DESIGN/PROCESS CHANGE NOTIFICATION

Description of Change (From) :

Strip mark position from heatsink side.

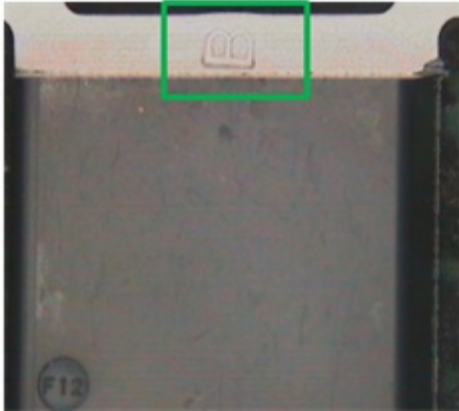
Description of Change (To) :

Strip mark position to heatsink area.

Reason for Change:

This is for process control improvement (mixing prevention) in conjunction with the yield improvement.

Changing the position will eliminate this yield loss of about 2% and also provide traceability of units in terms mixing control.
